Consumer Product Service
Manager of Tehnical Support
FIELD CHANGE ORDER number **1A**

MODEL:2600A ATARI Video Computer System

Consumer Product Service
Manager of Technical Support
UPGRADE BULLETIN

MODEL: Atari CX5200 Supergame (PCB CA018087)

Figure 1. Pin 24 Isolation.

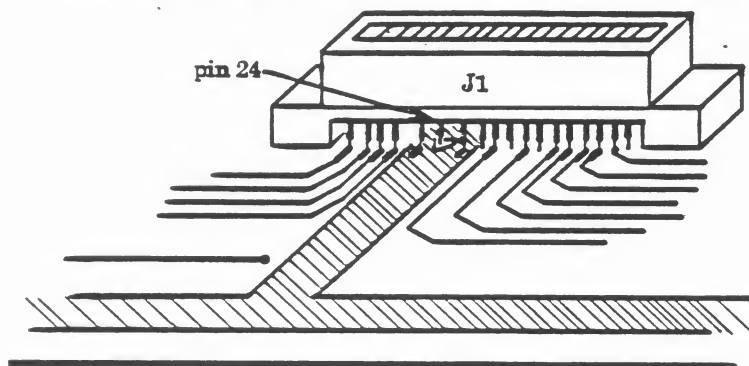
1. Remove the top cover of the CX5200.
2. Verify that the PCB Part Number is CA018087. (If it is not this number, there is no need for the modification. Reinstall cover, insert adaptor, go to step 13 and test.)
3. Remove both the top and bottom PCB shields.
4. Using either an X-ACTO knife or a Dremel tool (150 Bit), isolate Pin 24 of J1 from ground by making a "V" or "U" shaped cut in the trace on the component side of the PCB (See Figure 1). Be careful not to isolate Pins 23 and 25 from ground.

IT IS EXTREMELY IMPORTANT THAT PIN 24 OF J1 BE COMPLETELY ISOLATED FROM GROUND.

Use an Ohm Meter to verify that Pin 24 has been isolated from ground.

Figure 2. Pre-form Assembly

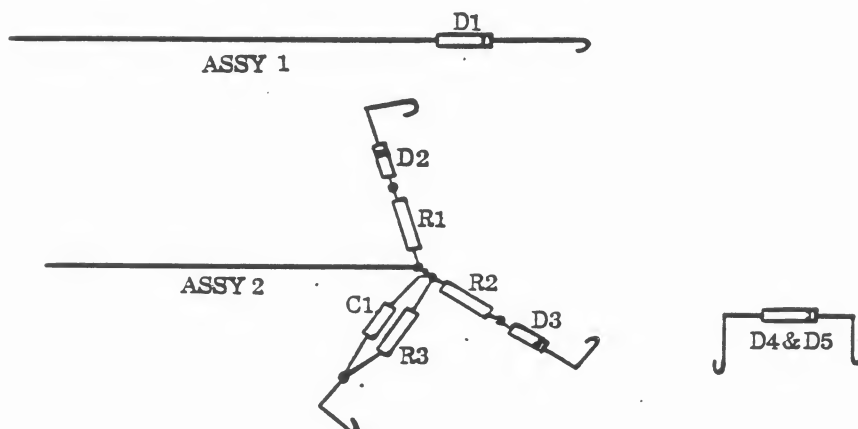
5. If the kit has not already been pre-formed (see Figure 2), use needle-nosed pliers and wire cutters to pre-form the kit. Use Figure 2 as a reference.

Figure 3. Retrofit Diagram.

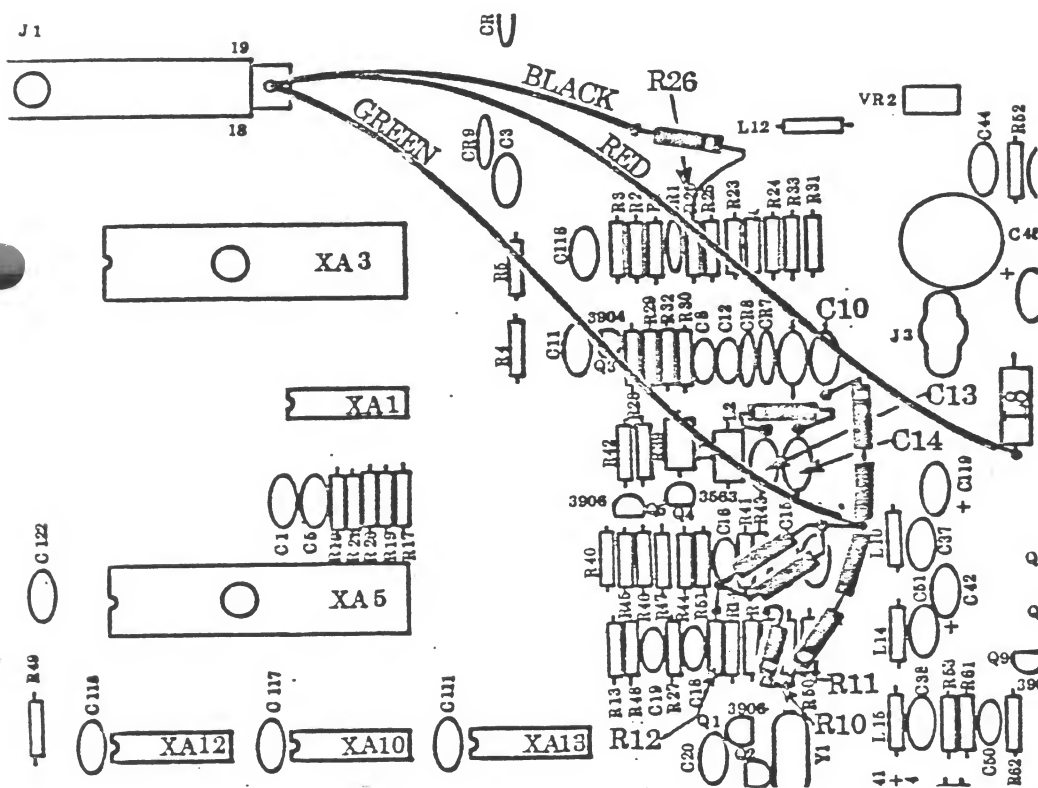
Using Figure 3 as a reference perform the following:

- A. Solder cathode of D1, Assembly 1 to R26.
- B. Pass Assembly 1 wire, (BLACK) through hole in J1.
- C. Solder cathode of D4, to C13.
- D. Solder anode of D4, to C14.
- E. Solder D5 to R10 (Note polarity).
- F. Solder cathode of D2, Assembly 2 to C10.
- G. Solder cathode of D3, Assembly 2 to R11.
- H. Solder R3, and C1, Assembly 2 to R12.
- I. Pass Assembly 2 wire (GREEN) through hole in J1.
- J. Solder one end of RED jumper wire to L8.
- K. Pass RED jumper wire through hole in J1.

Figure 4. Wire Connection Diagram.

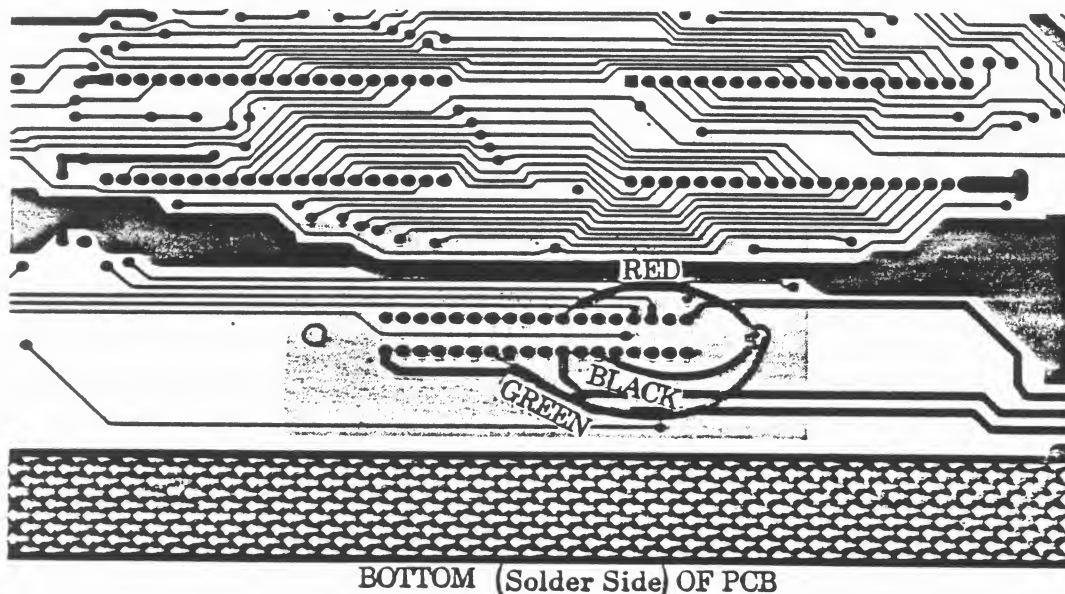
7. Using Figure 4 as a reference, perform the following:

- A. Solder Assembly 1 wire (BLACK) to Pin 24 of J1.
- B. Solder Assembly 2 wire (GREEN) to Pin 30 of J1.
- C. *Solder RED jumper wire to Pin 11 of J1.

After soldering, use an Ohm Meter to make sure that no solder bridges or shorts were formed adjacent to Pins 11, 24, and/or 30 of J1.

* = Take extra care to avoid connecting the RED wire to any ground pins. If the RED wire is grounded, the 5200 Power Adaptor will burn out.

Figure 5. Top Cover Pin Removal

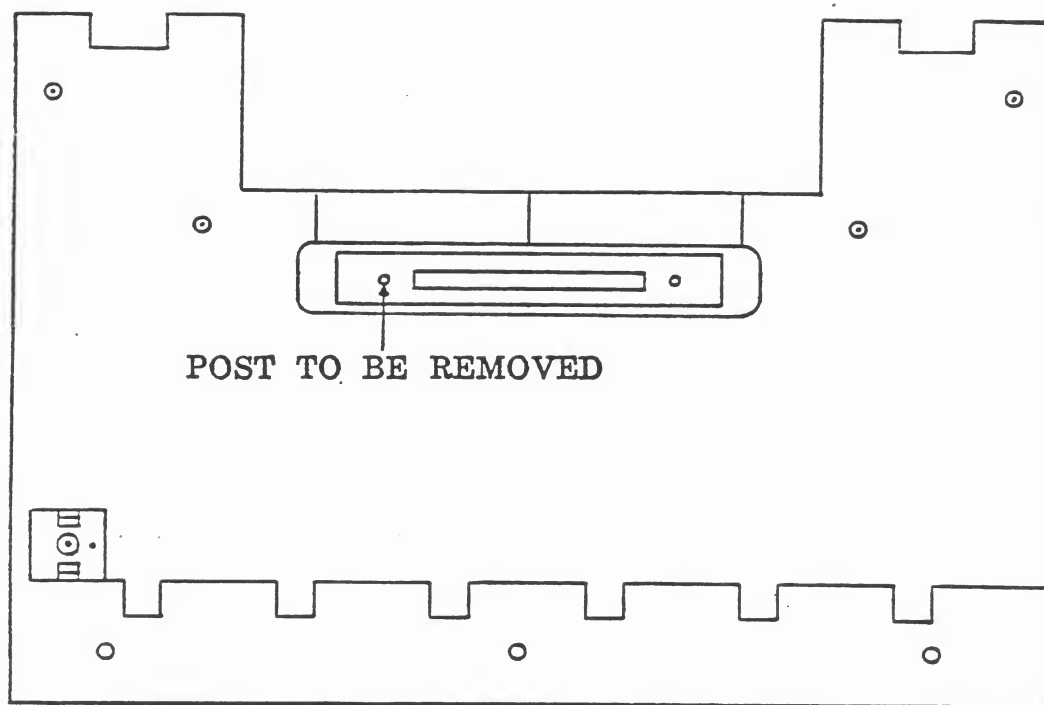
- 8. Place the top housing face down on the workbench.
- 9. Using needle-nosed pliers, grasp the pin indicated in Figure 5, and twist it off.
- 10. Before reassembling the unit, place the PCB into the bottom housing and replace the top housing. DO NOT SECURE HOUSINGS.
- 11. Using the 1.1 Diagnostic Cartridge perform a quick check to ensure that the modifications did not affect the performance of the unit. If the unit fails, return to the modification procedures, and make certain that all steps were fully and completely performed. The modifications will not affect game play or the unit's performance.
- 12. Turn off the unit.

Figure 1. Pin 24 Isolation.

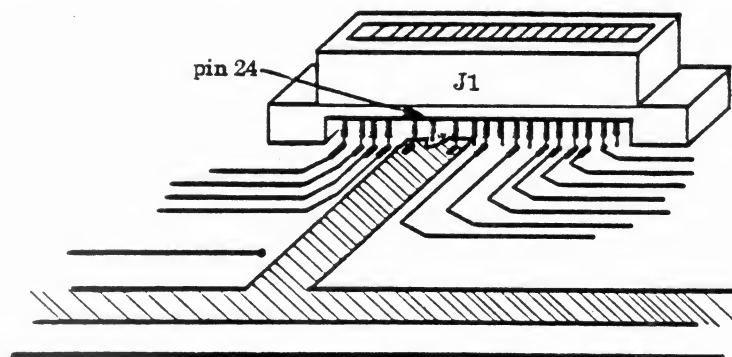
1. Remove the top cover of the CX5200.
2. Verify that the PCB Part Number is CA018087. (If it is not this number, there is no need for the modification. Reinstall cover, insert adaptor, go to step 13 and test.)
3. Remove both the top and bottom PCB shields.
4. Using either an X-ACTO knife or a Dremel tool (150 Bit), isolate Pin 24 of J1 from ground by making a "V" or "U" shaped cut in the trace on the component side of the PCB (See Figure 1). Be careful not to isolate Pins 23 and 25 from ground.

IT IS EXTREMELY IMPORTANT THAT PIN 24 OF J1 BE COMPLETELY ISOLATED FROM GROUND.

NOTE: The ground plane does not go all the way under the cart socket so you can cut it as stated.

Use an Ohm Meter to verify that Pin 24 has been isolated from ground.

Figure 2. Pre-form Assembly

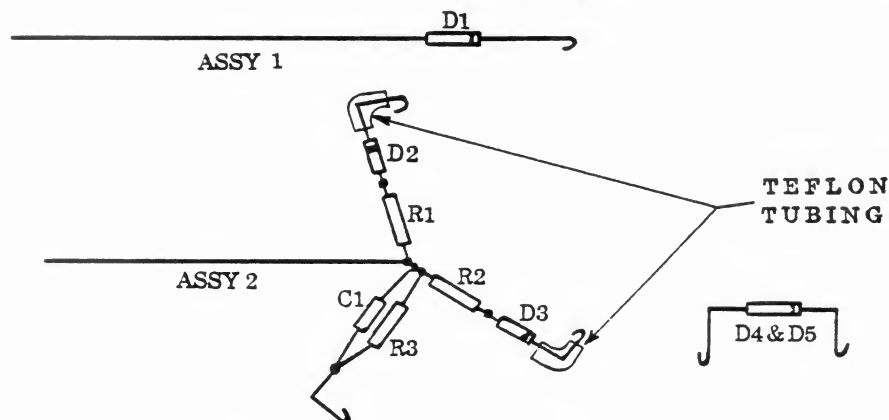
5. If the kit has not already been pre-formed (see Figure 2), use needle-nosed pliers and wire cutters to pre-form the kit. Use Figure 2 as a reference.

Figure 3. Retrofit Diagram

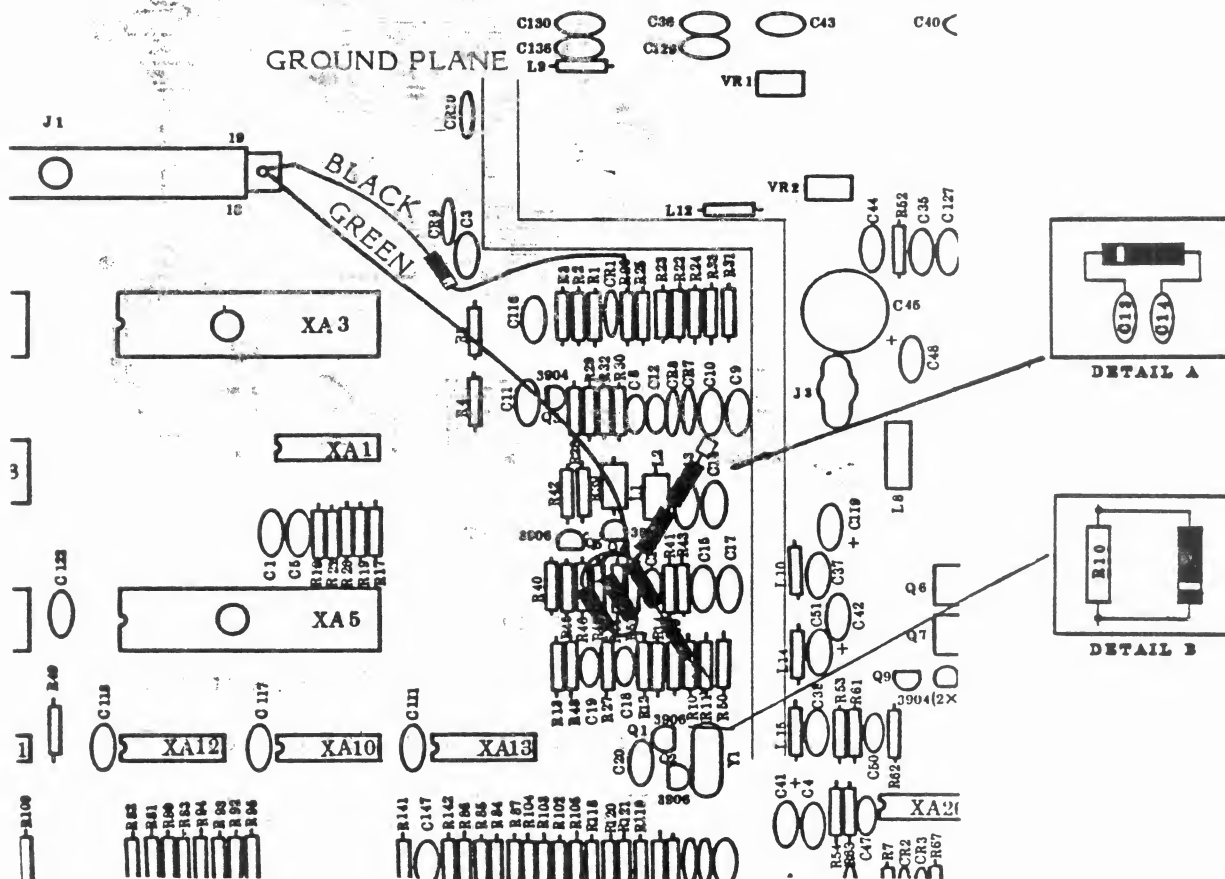
6. Using Figure 3 as a reference perform the following:

- A. Solder cathode of D1, Assembly 1 to R26.
- B. Pass Assembly 1 wire, (BLACK) through hole in J1.
- C. Solder cathode of D4, to C13 (See Detail A).
- D. Solder anode of D4, to C14 (See Detail A).
- E. Solder D5 to R10 (Note polarity). See Detail B.
- F. Solder cathode of D2, Assembly 2 to C10.
- G. Solder cathode of D3, Assembly 2 to R11.
- H. Solder R3, and C1, Assembly 2 to R12.
- I. Pass Assembly 2 wire (GREEN) through hole in J1.

NOTE: Ensure that assy. 2 is not positioned in such a way that when the shield is placed back on the unit the components short against the shield. If it does, this may result in damage to the 5200 or cartridge adaptor.

Figure 4. Wire Connection Diagram.

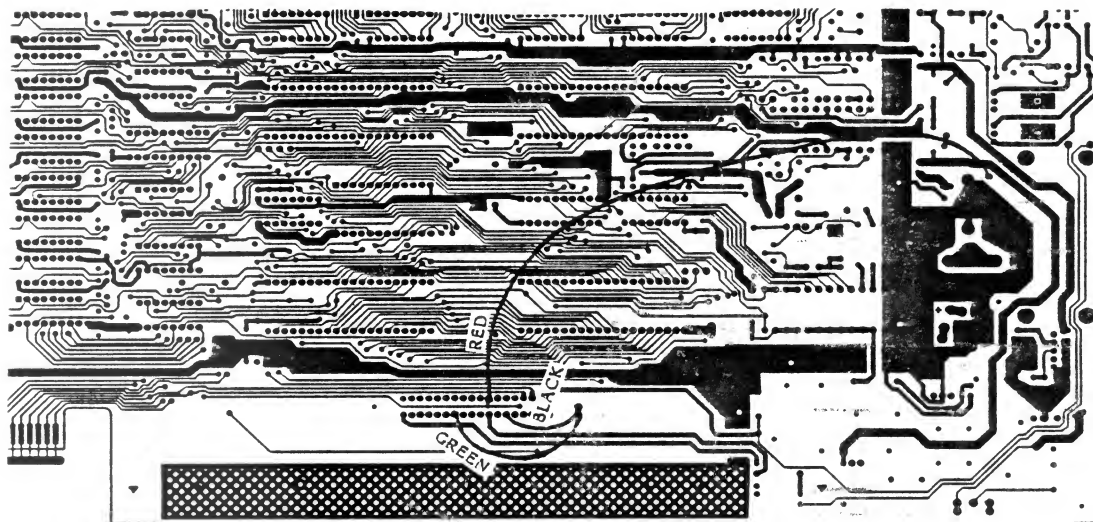
7. Using Figure 4 as a reference, perform the following:

- A. Solder Assembly 1 wire (BLACK) to Pin 24 of J1.
- B. Solder Assembly 2 wire (GREEN) to Pin 30 of J1.
- C. *Solder RED jumper wire to Pin 11 of J1.
- D. *Solder other end of RED wire to bottom leg of L8.

After soldering, use an Ohm Meter to make sure that no solder bridges or shorts were formed adjacent to Pins 11, 24, and/or 30 of J1.

* = Take extra care to avoid connecting the RED wire to any ground pins. If the RED wire is grounded, the 5200 Power Adaptor will burn out.

Figure 5. Top Cover Pin Removal

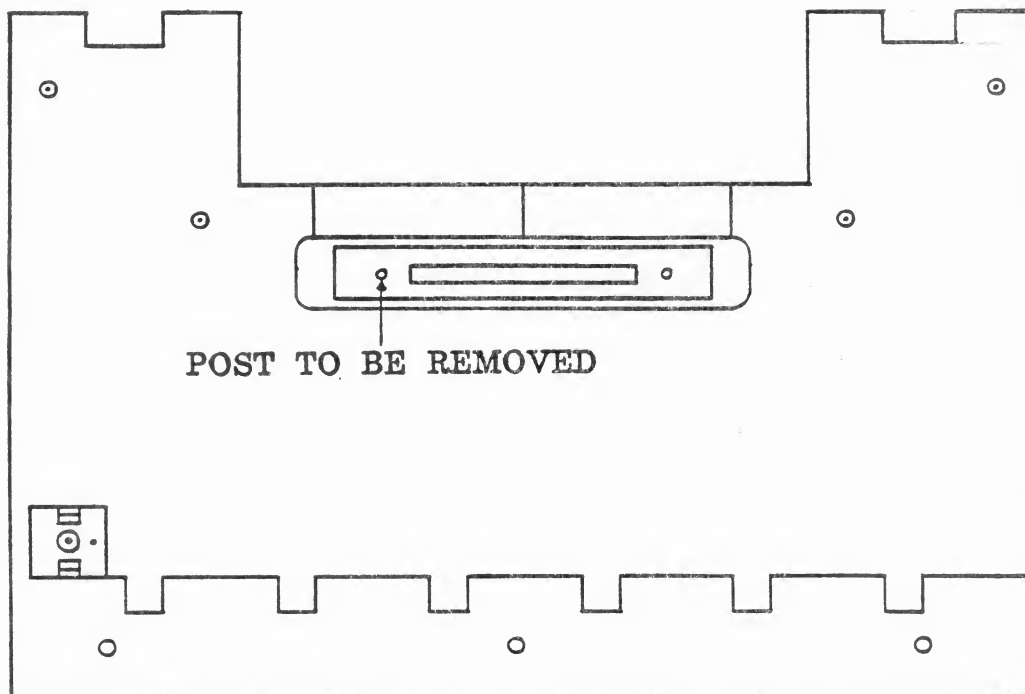
- 8. Place the top housing face down on the workbench.
- 9. Using needle-nosed pliers, grasp the pin indicated in Figure 5, and twist it off.
- 10. Replace the shielding on the unit ensuring that the red wire is routed as in Fig. 4.
- 11. Before reassembling the unit, place the PCB into the bottom housing and replace the top housing. DO NOT SECURE HOUSINGS.
- 12. Using the 1.1 Diagnostic Cartridge perform a quick check to ensure that the modifications did not affect the performance of the unit. If the unit fails, return to the modification procedures, and make certain that all steps were fully and completely performed. The modifications will not affect game play or the unit's performance.
- 13. Turn off the unit.

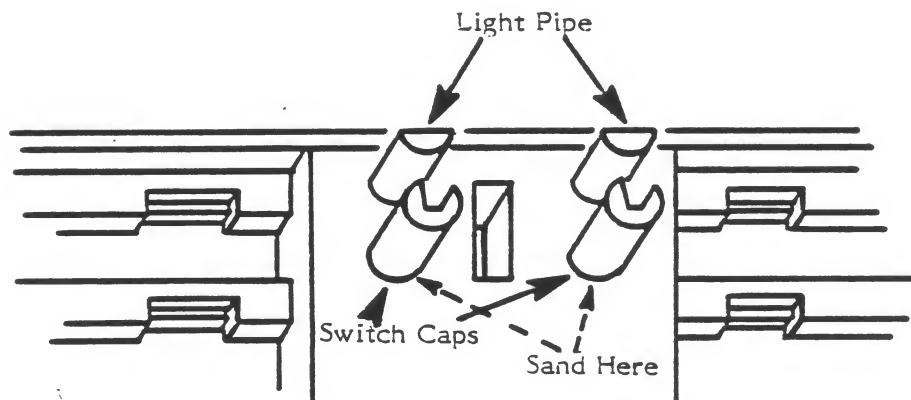
If at power-up two switches are activated at the same time (indicated by both the Joystick and Paddle, or Novice and Expert LED's "on" at the same time), you must shorten the switchcap hand ends with sand paper, to eliminate binding.

If the switchcaps seem to be binding when activated on Rev. 4 PCBs, tilt the momentary switches (S2-S9) toward the player port side of the board so that there is a .030 inch gap between the board and the leading edge of the switch bottom (a manual approximation is usually successful). Some Rev. 4 PCB's have a shim glued to the PCB to correct this problem.

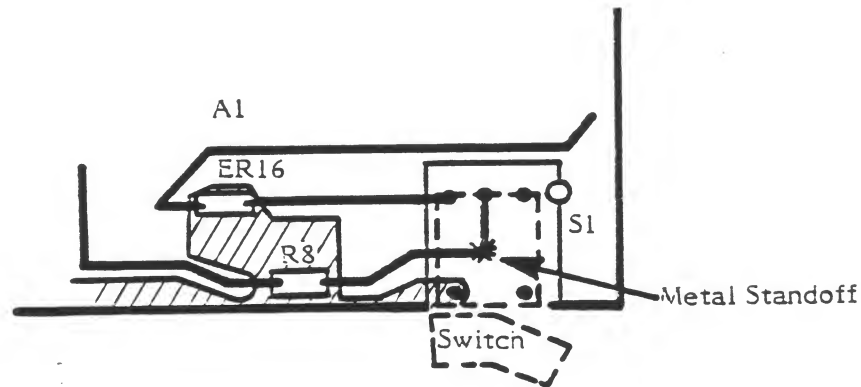
The Rev. 4 CX2800 PCB switch S1 (On/Off) has a metal standoff that may short to the trace beneath the switch. To prevent shorting, place a small piece of insulating tape on the board beneath the switch. PCB to Rev. 4 and above have the traces rerouted.

Figure 1. CX5200 Schematic (R-C Network)

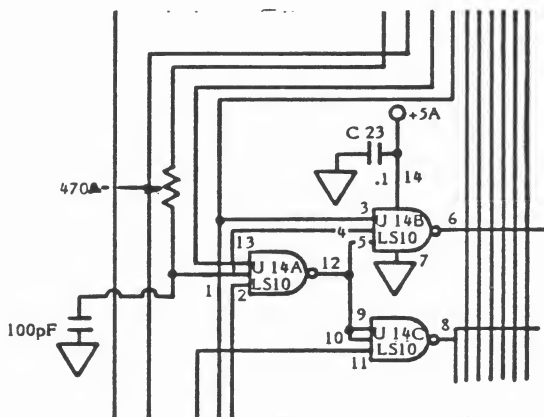
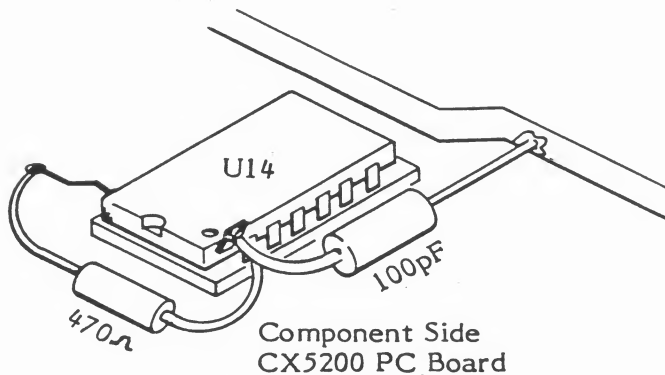
Rockwell MPUs with date code of 8250 and later (stamped with the letters RC) have a timing defect.

A factory modification adds an R-C network on the component side of the CX5200 PC Board, at IC U14A (pin 1) and U6A (pin 4) (see Figures 1 and 2).

Figure 3. R-C Network (Add to solder side of CX 5200 PC Board)

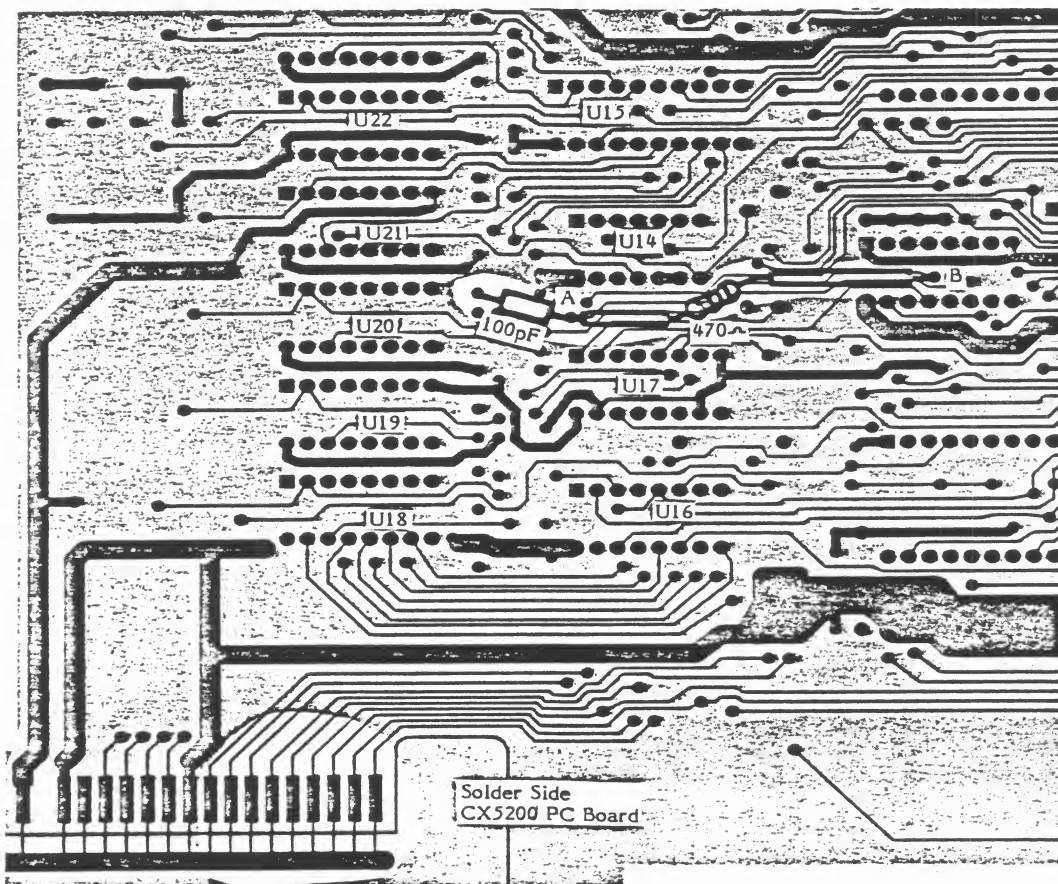
If you are installing an RC stamped 6502 on a CX5200 PC Board which has not had the factory modification added to the component side:

Add an R-C network to the solder side of the PC Board (See Figure 3).

See Figure 3 for the following steps:

1. Straighten the lead of C27 (solder side) and solder one lead of the 100 pf capacitor to it.
2. Point A is an unoccupied well between IC's U14 and U17. It is connected directly to Pin 1 of U14. Cut the trace running between points A and B as close to Point A as possible. Use a DVM to insure that the trace is now open.
3. Add sleeving to one lead of the 470 Ω resistor. Insert the lead into the well at Point A and solder.
4. Wrap the remaining lead of the 100 pf capacitor around the lead of the 470 Ω resistor at Point A and solder.
5. Remove the solder from well at Point B which is directly beneath U6. Add sleeving to the remaining lead of the 470 Ω resistor. Insert this lead into the hole at Point B and solder.

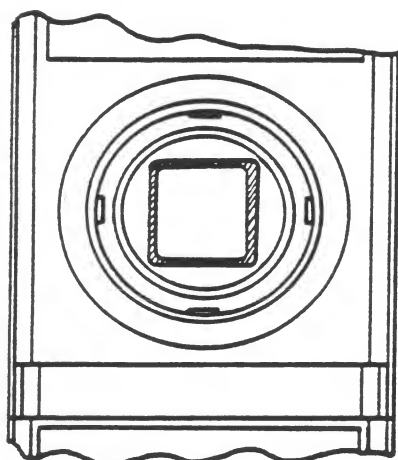
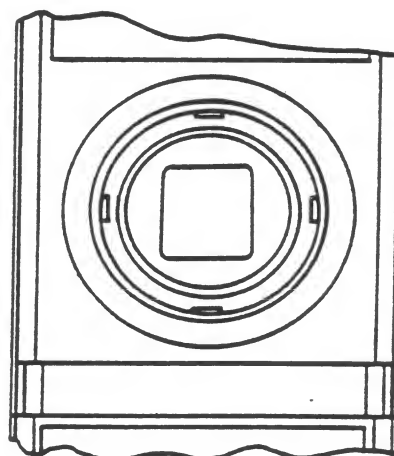
Repair CX5200 Controllers with damaged boots in the following manner:

- 1) Follow Disassembly instructions for the CX5200 Controller in the CX5200 Field Service Manual.
- 2) Remove the top controller case and pull off the joystick handle.
- 3) Remove the boot retaining ring. Remove and discard the damaged boot.
- 4) If the top controller case contains the square ridge around the access well, as illustrated in "A" below, remove and discard it. Replace it with the new top controller case in which this square ridge has been removed, as illustrated in "B".

Figure 1. 5200 PCB Solder Side at J1

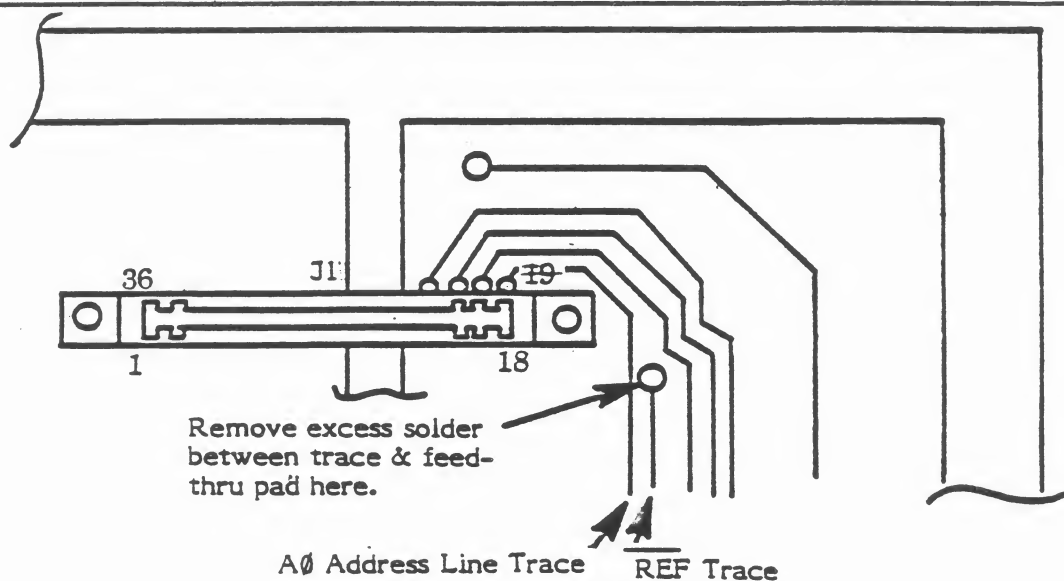
Some 5200 units display a blank dark screen or a screen with garbled information. The probable cause for either of these symptoms is an intermittent solder short (bridge) on the PCB between the A0 Address line trace and the feedthru pad of the REF Line trace (near connector J1).

- 1) Turn off power, and disconnect AC and interconnect cables.
- 2) Disassemble unit to expose the component side of the PCB (CA018087).
- 3) Locate connector J1, the adjacent A0 Address trace and the feed-thru pad of the REF Trace (See Figure 1).
- 4) Carefully remove the excess solder from the pad and wipe the area clean. Inspect the pad and if necessary use an X-acto knife to cut a shallow groove between the A0 Address Line and the feedthru pad. Be very carefully not to nick or cut the trace adjacent to the pad.
- 5) Reassemble and test the unit.
